Please find enclosed a revised version of our manuscript entitled “AUV based self-potential observation” by Zhongmin Zhu, Jinsong Shen, Chunhui Tao, Xianming Deng, Tao wu, Wenyi Wang, Zuofu Nie and Chaoyang Su for submission to GI. The comments by the referee have been accounted for and are discussed below in details. A revised version of the manuscript with the changes overlaid in yellow is also provided Thanks for your time and professionalism.

Referee, kai Chen:

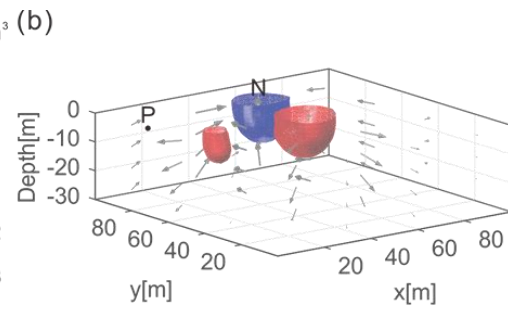
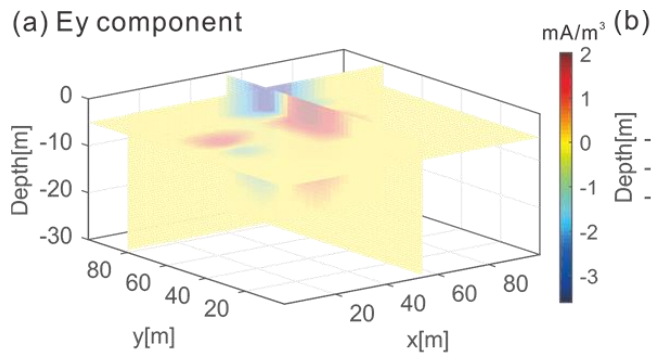
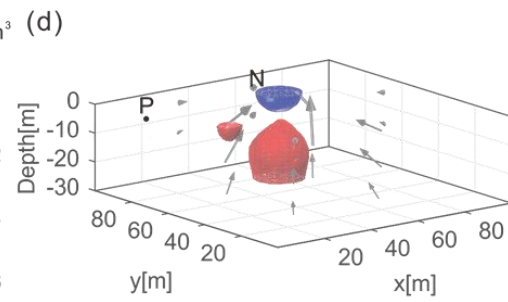
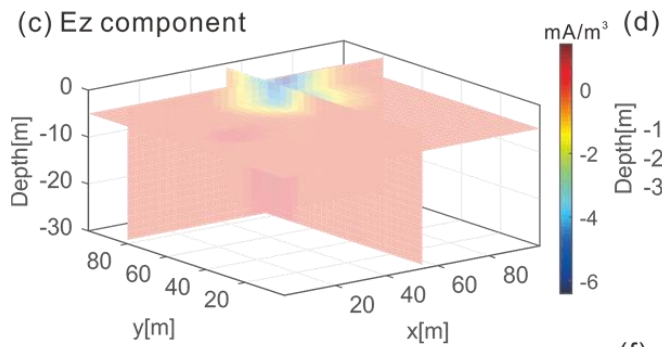
4. The Referee wrote: “The heat map in Figure 7 should add units” Response: units have been added, sorry for the mistake.
